DOUGHTY

ART FORM ARCHITECTURE, INC.

APR 03 2012

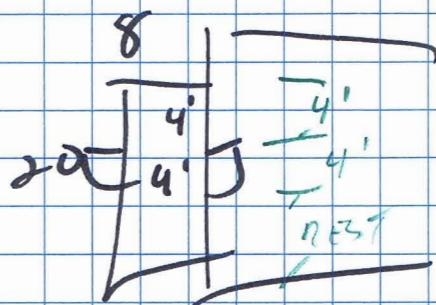
1) ADD WOOD SHED

SCREENED VENTS

2) ROOF RIDGE VENT
SHOULD BE 2 FT
ABOVE CONNECTION ROOF
